Seismic Walkdown Checklist (SWC)Equipment ID No. 2-1805-53-BBC Equip. Class¹² Motor Control Centers & Wall-Mounted ControllersEquipment Description 480V MOT Control CTR 2BBCLocation: Bldg. Control Floor El. 180'-0" Room, Area R/B18

Seismic Walkdown Checklist (SWC)Equipment ID No. 2-1806-S3-DCC Equip. Class¹² 1-Motor Control Centres and Wall-mounted ControllersEquipment Description 125 VDC MCC 2C D1MLocation: Bldg. Control Floor El. 180'-0" Room, Area RB85

2BBC-22

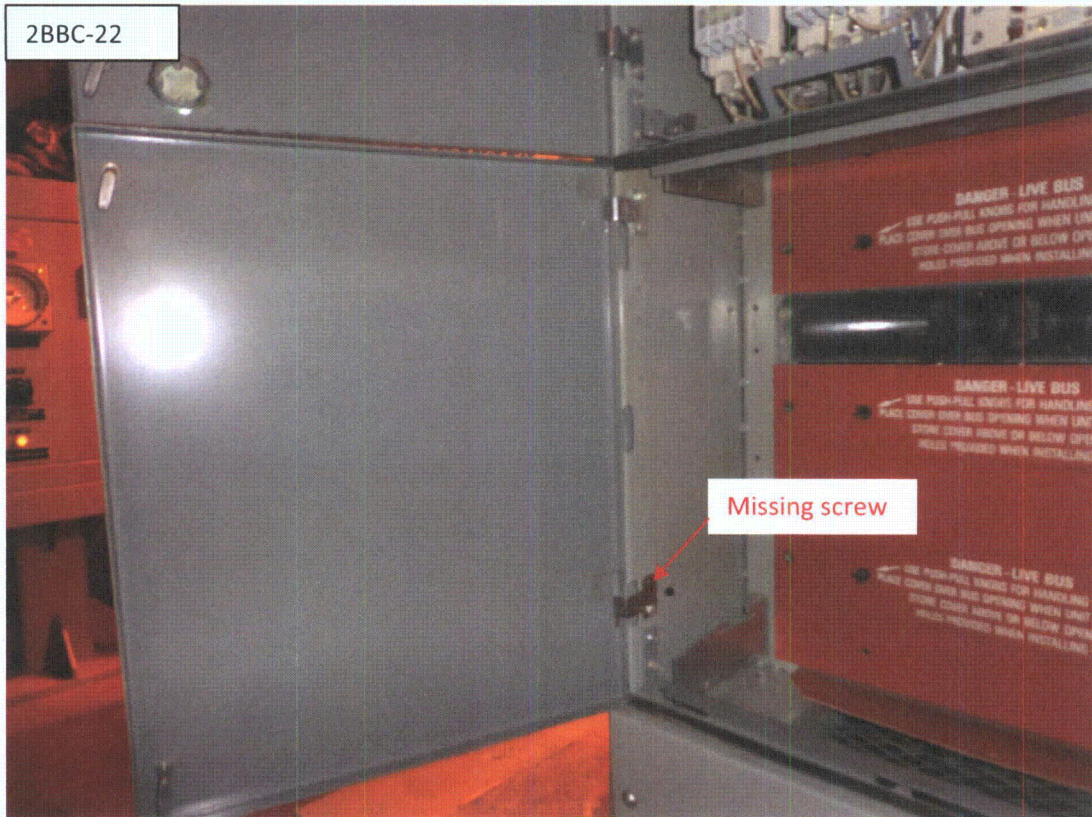
- One (1) missing screw for a door hinge in compartment 2BBC-22.
- One (1) missing screw for a door hinge in the top of the 4th compartment.
- One (1) door that could not be opened for compartment 2BBC-18.

It has been judged by the SWB team that these issues do not represent a seismic or operability concern for this cabinet. Condition Report 611859 has been generated to document the condition.

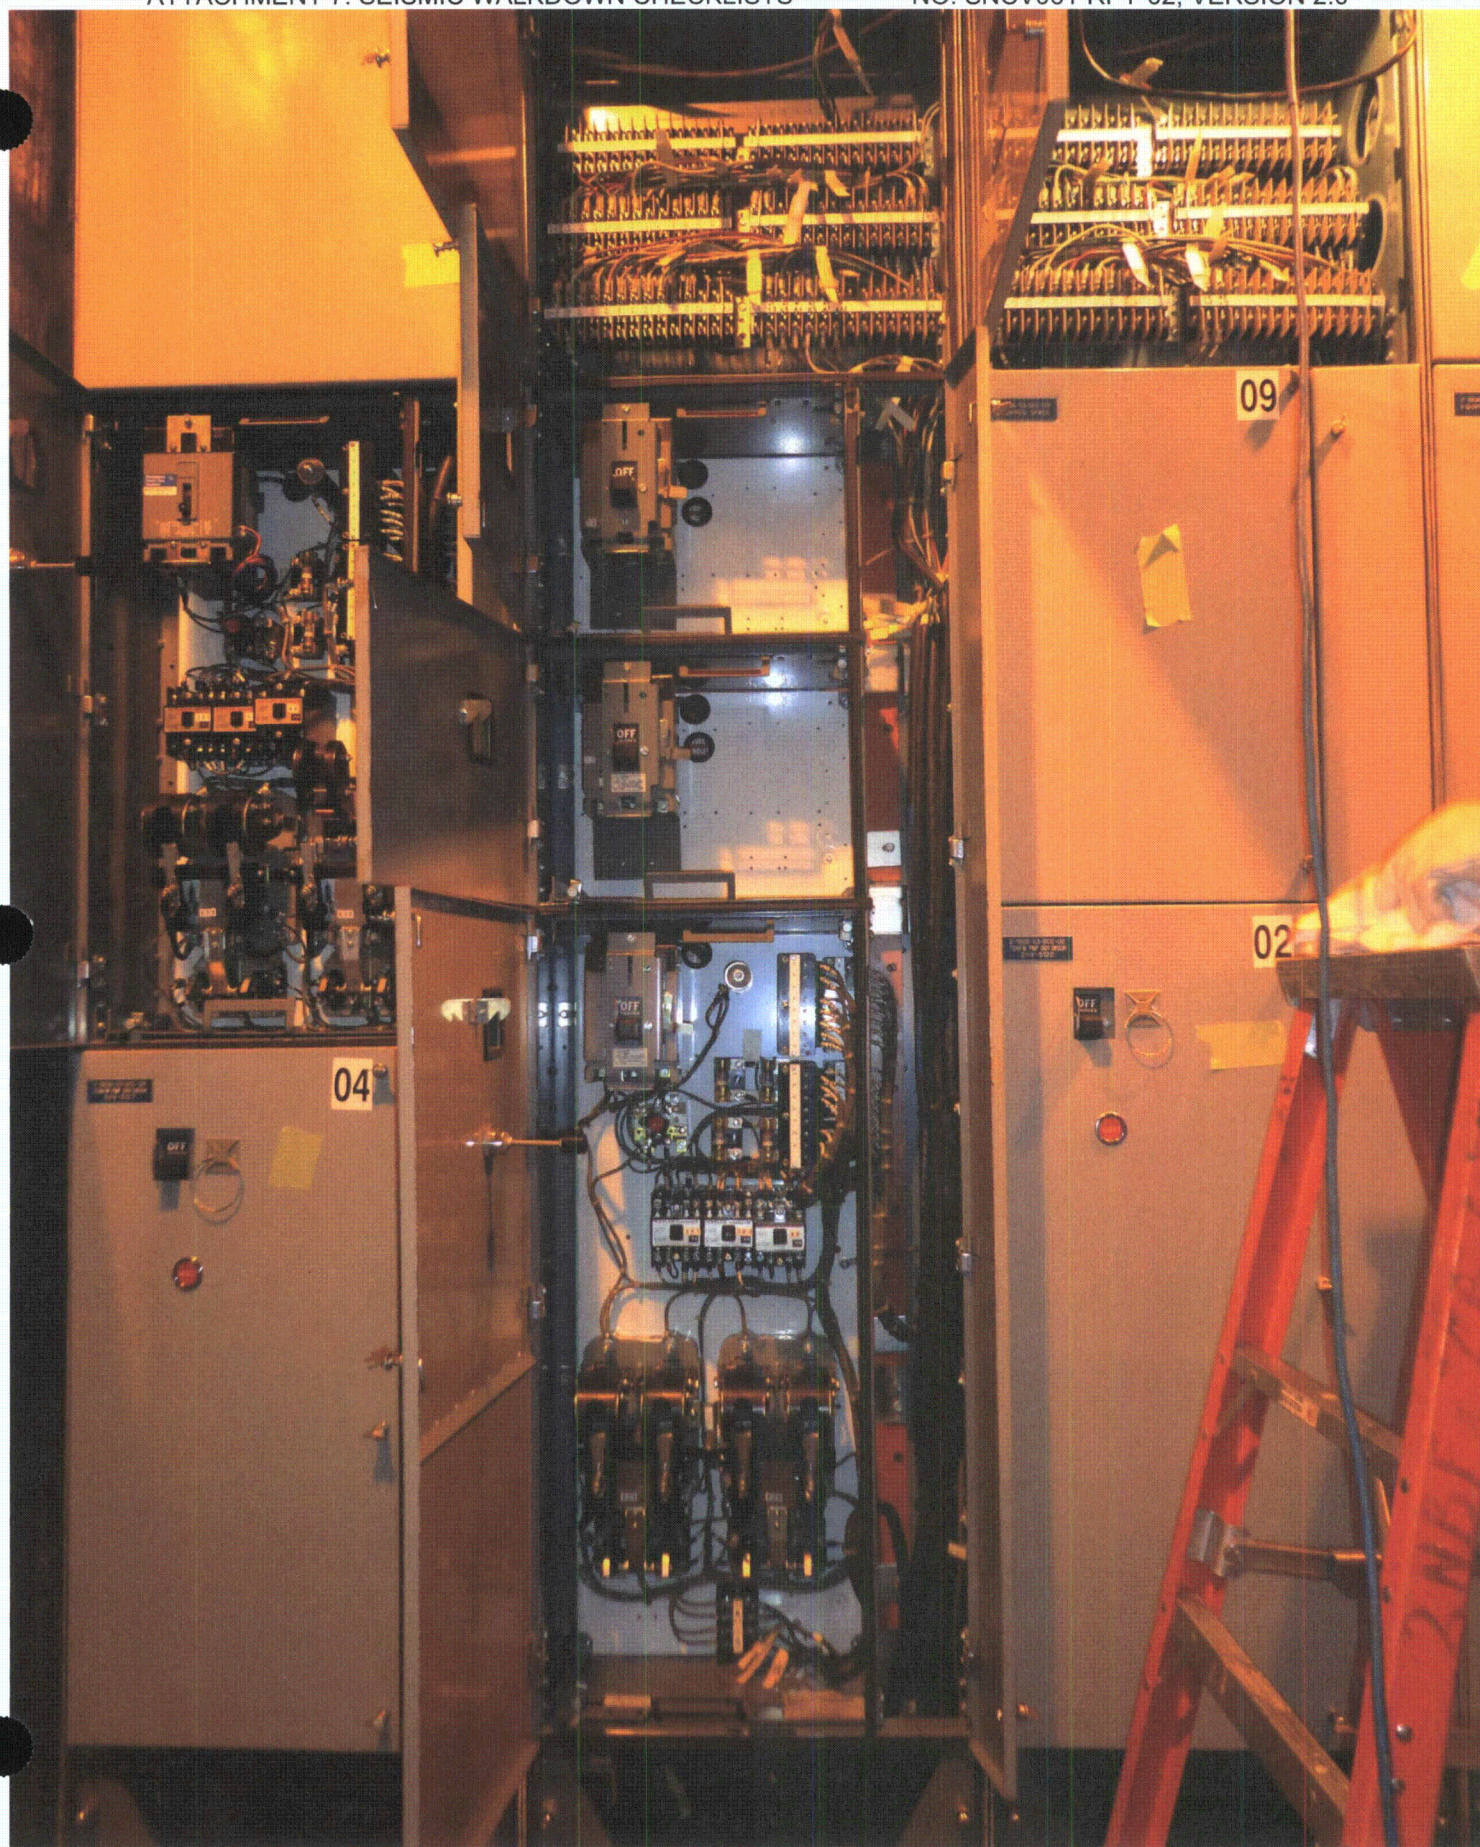
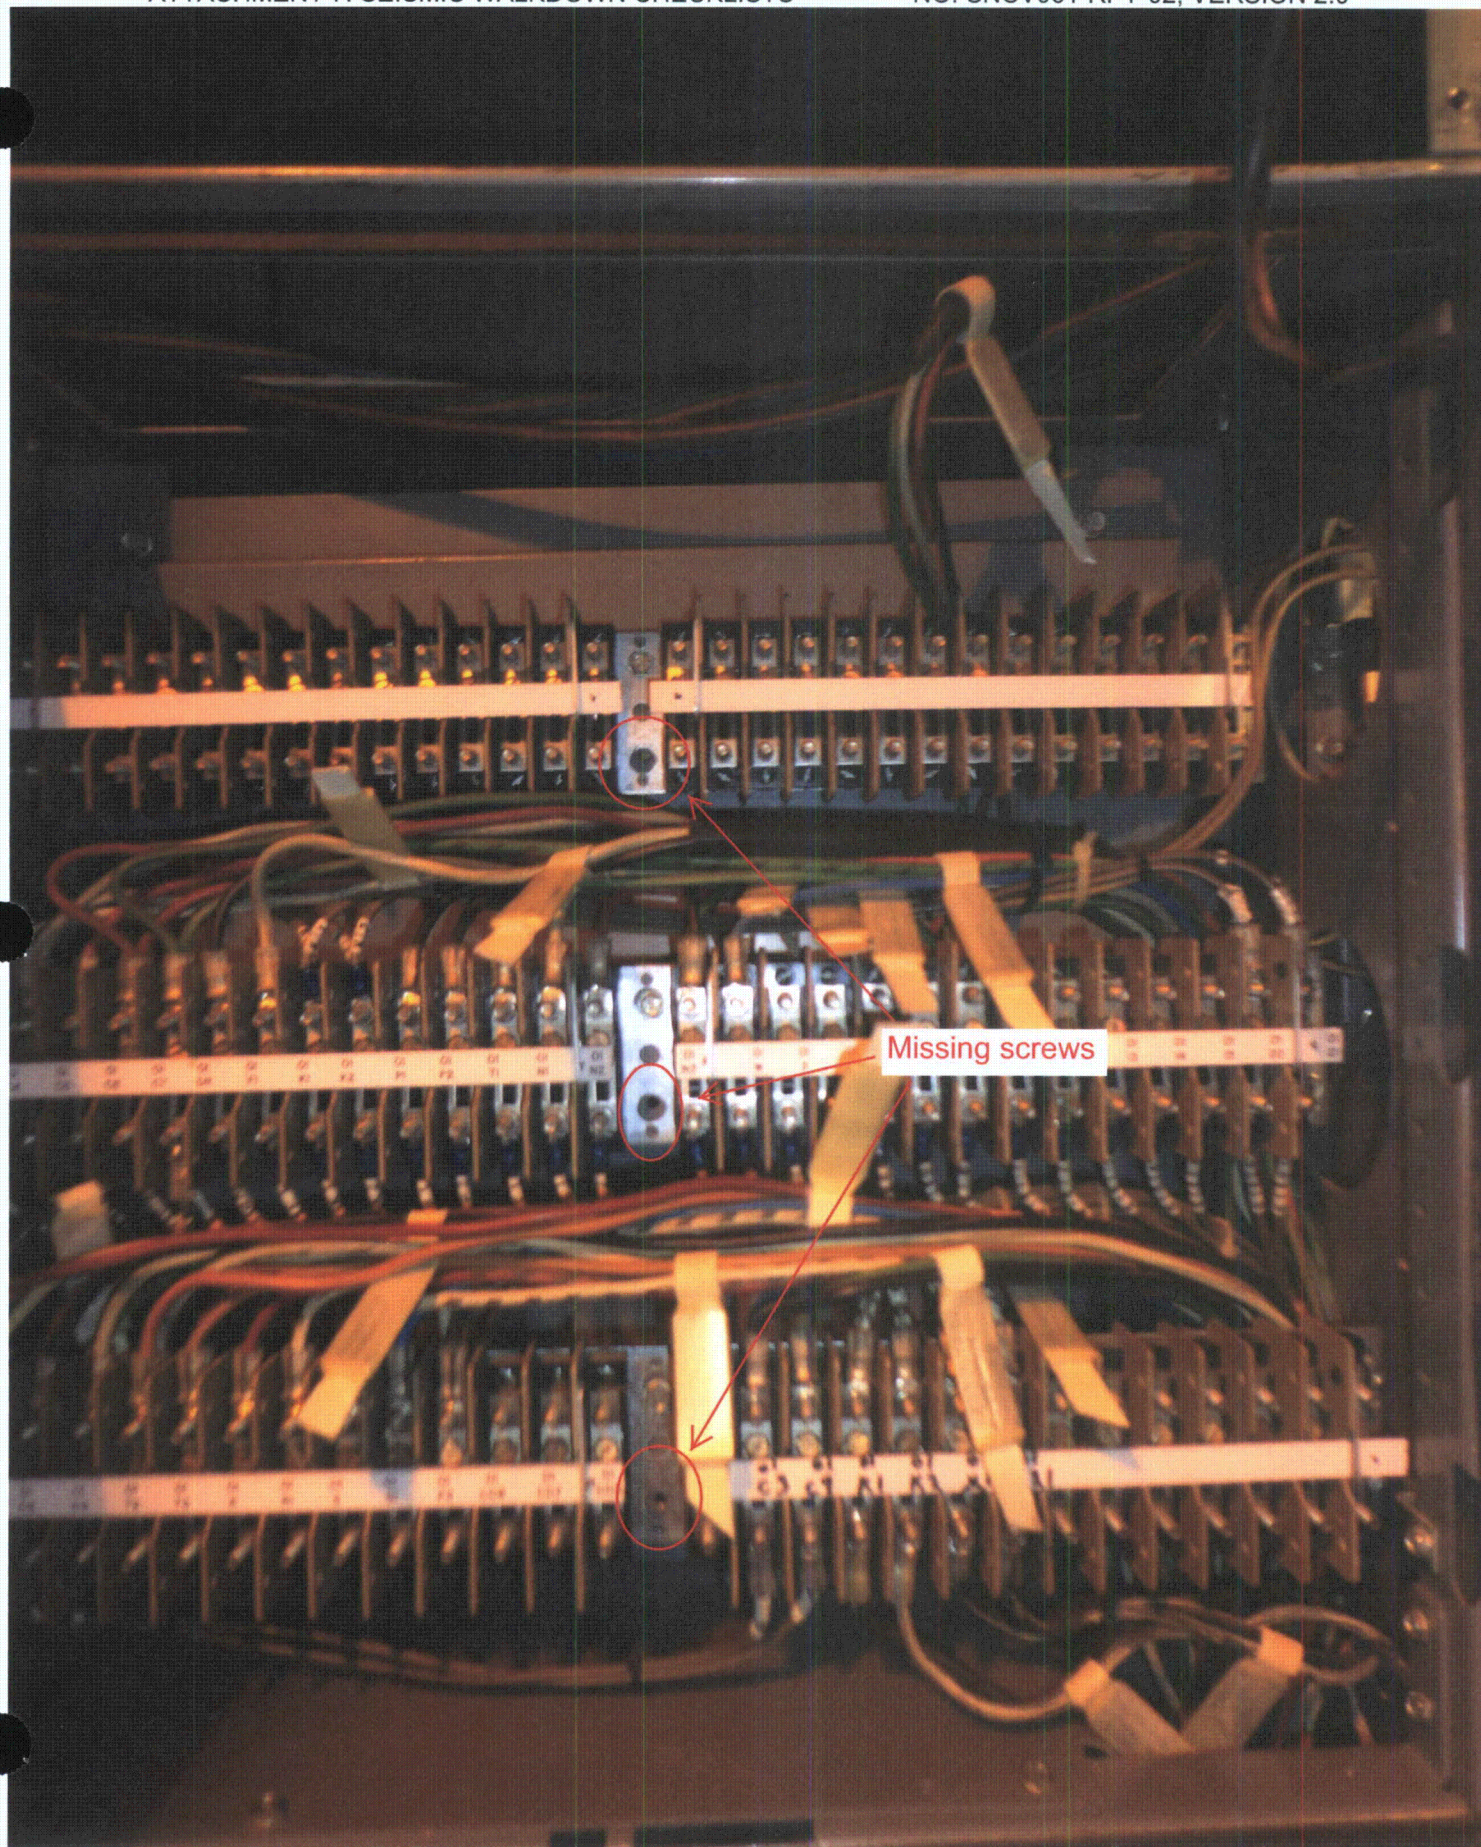
① A minor issue was found: three (3) screws for terminal blocks were missing. It has been judged by the SWE team that this condition does not represent a seismic or operability concern for this cabinet. Condition report 604433 has been generated to document the condition.
